April 14, 2020

Arlington Conservation Commission
730 Massachusetts Avenue Annex
Arlington, MA 02476

**Re: Supplemental Information to Notice of Intent
77 Sunnyside Avenue (DEP File #091-0320)
Arlington, MA**

EXISTING
ELEVATIONS

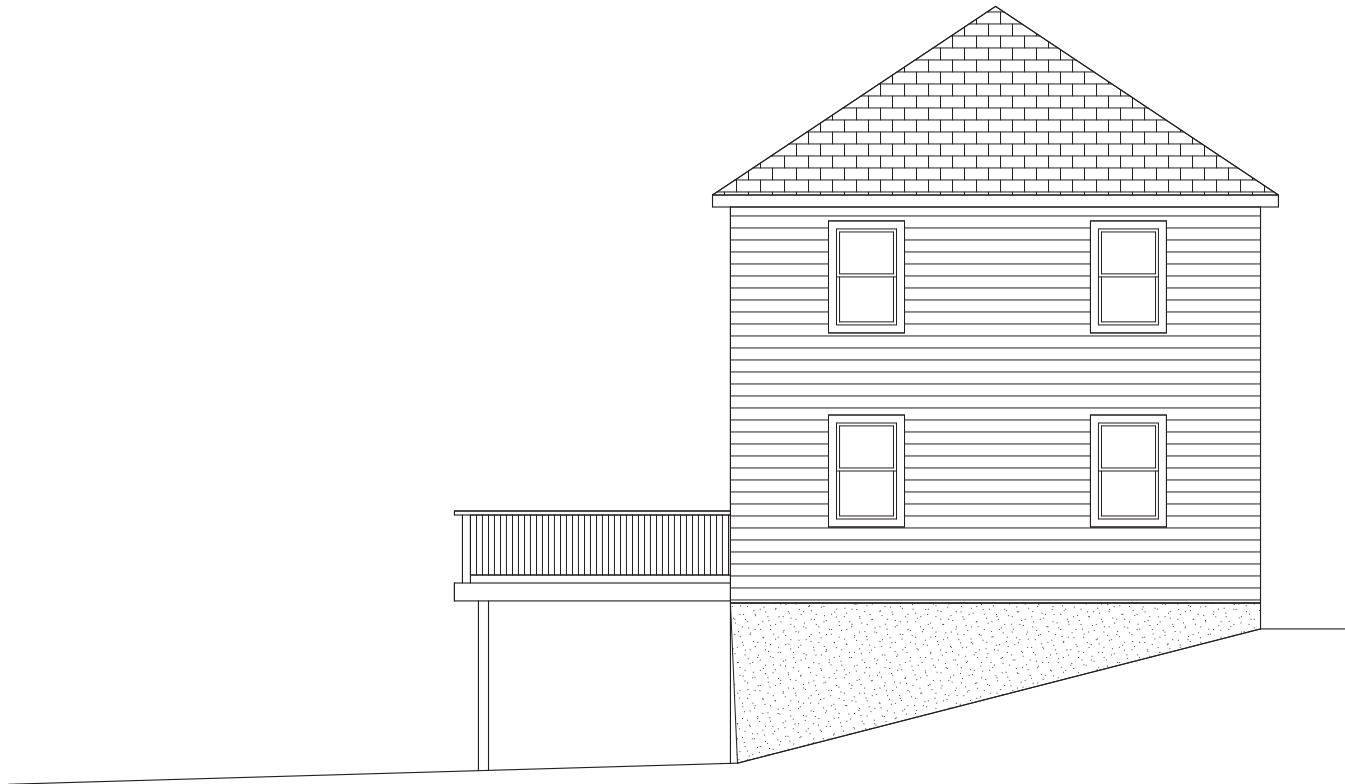
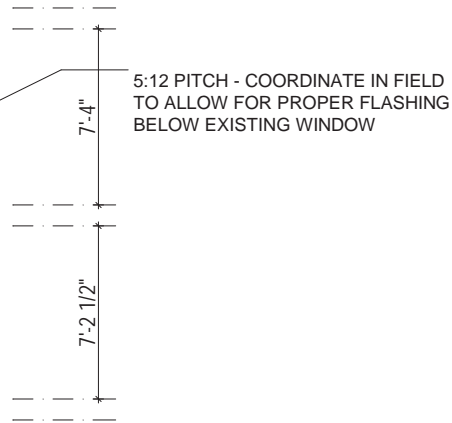
3) Regarding the request for a profile view of the proposed addition

We have attached architectural plans from Miller Design LLC (dated February 2, 2020) showing the profile view of the current existing conditions, and the proposed addition and deck, for your convenience.
